**CITY OF NORTH ST. PAUL PLANNING COMMISSION
REGULAR MEETING AGENDA
THURSDAY, FEBRUARY 6th, 2020
6:15 PM**

A. Rezoning, Major Subdivision (preliminary plat), and Preliminary Planned Unit Development – 2242 7th St. N. and 2231 6th St. N.

Date: 1/30/2020
To: Planning Commissioners
From: Erin Perdu, AICP, City Planner
Ryan Krzos, AICP, Planning Consultant
CC: Scott Duddeck, City Manager
Debra Gustafson, Administrative and Community Services Director
Re: Preliminary Plat for property at 2242 7th Street N and 2231 6th Street N; and Rezoning from R-1 to R-2 and Preliminary Planned Unit Development Review for 2242 7th Street N

PRELIMINARY PLANS FOR THE
7TH STREET TOWNHOMES
NORTH ST. PAUL, MN
JANUARY, 2020

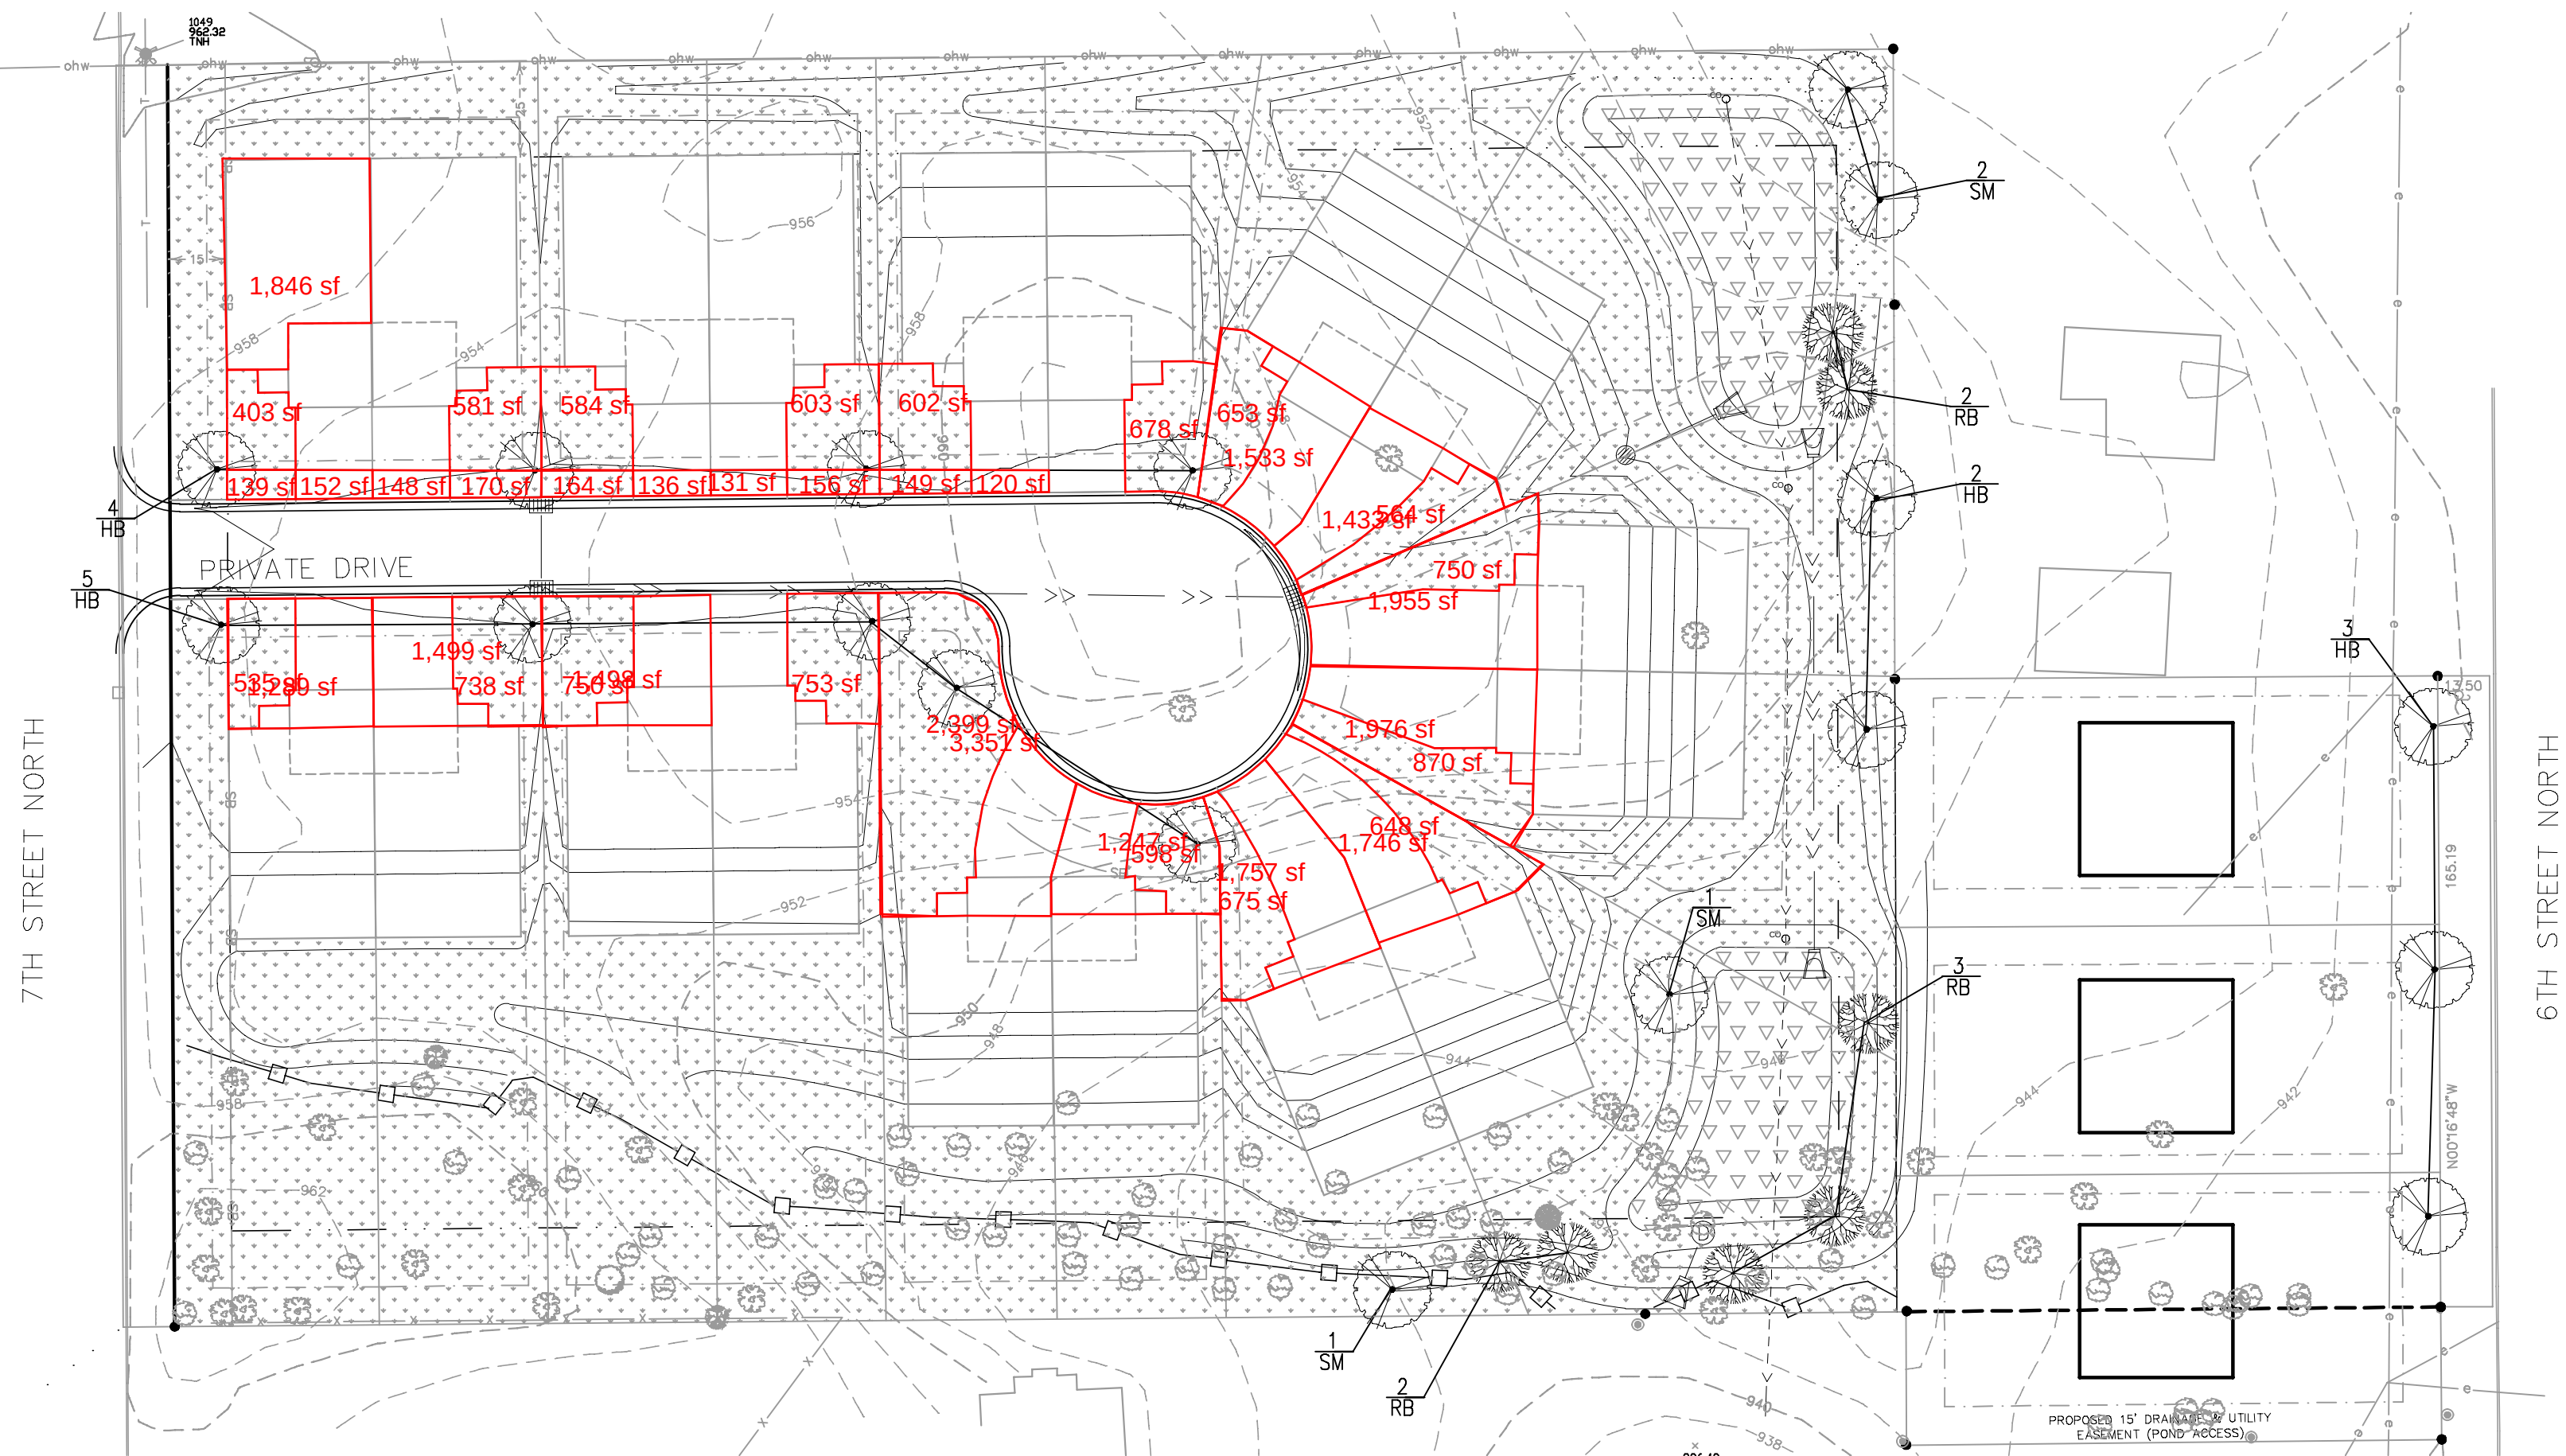
The proposed landscaping plan shows several tree plantings within the proposed drainage and utility easement encompassing the stormwater detention facilities. In accordance with the above noted standard, these plantings will need to be relocated on a revised landscaping plan.

A landscaping plan was included in the application submittal. The proposed 18 units of townhomes and three single family dwellings requires 21 trees (one tree per residential unit). The proposed landscaping plan shows 25 trees of three species: River Birch, Hackberry, and Sienna Glen Maple. Eight of the proposed trees are located on either side of the proposed roadway serving the townhomes, and three along the west side of 6th Street N in front of the three single-family home sites. Clusters of proposed River Birch plantings are located around the sides of the two stormwater detention facilities. As previously noted, plantings are not permitted within drainage and utility easements, therefore said plantings must be relocated on a revised landscaping plan.
